PIC32MZ EF FAMILY

PIC32MZ Embedded Connectivity with Floating Point Unit (EF) Family Silicon Errata and Data Sheet Clarification

The PIC32MZ Embedded Connectivity with Floating Point Unit (EF) family of devices that you have received conform functionally to the current Device Data Sheet (DS60001320), except for the anomalies described in this document.

FIGURE 1: Posc CRYSTAL CIRCUIT

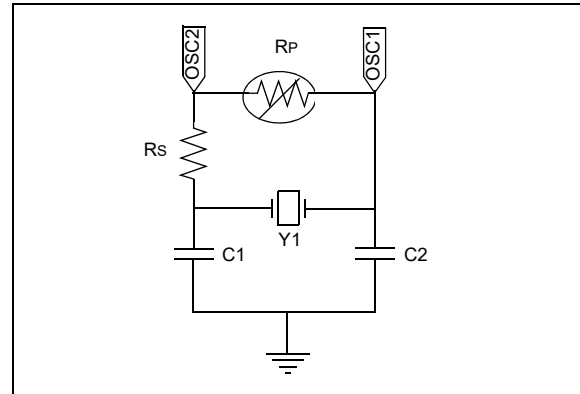
Revision A3 and B3 Silicon: The POSC has been tested in a normal power-up sequence and supports specific crystal operation.

The Primary Oscillator (Posc) has been characterized to operate at 8 MHz, 12 MHz, and 24 MHz when the circuit in [Figure 1](#) is implemented, and the operating conditions listed in [Table 3](#) are met.

TABLE 3: CRYSTAL SPECIFICATIONS

Crystal Frequency (see Note 1)	Series Resistor (Rs)	Posc Gain Setting POSCGAIN<1:0> (DEVCFG0<20:19>)	Posc Boost Setting POSCBOOST (DEVCFG0<21>)
8 MHz	2 kΩ	'0b00 (GAIN_0)	'0b1 (ON)
12 MHz	1 kΩ	'0b00 (GAIN_0)	'0b1 (ON)
24 MHz	0 kΩ	'0b00 (GAIN_0)	'0b1 (ON)

- Note 1:** Using any other crystal frequency will require special component selection and characterization.
Note 2: A parallel resistor (Rp) should not be used to increase the gain of the POSC.

64-PIN QFN⁽⁴⁾ AND TQFP (TOP VIEW)

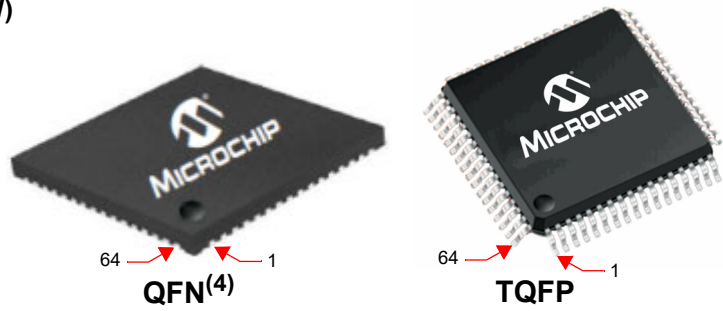
In Table 2. “Pin Names for 64-pin QFN and TQFP Devices” of the current data sheet, the AECRS_{DV} signal was erroneously omitted from the pin number 44 and added to the pin number 62. The correct assignment is shown in bold type in the following table.
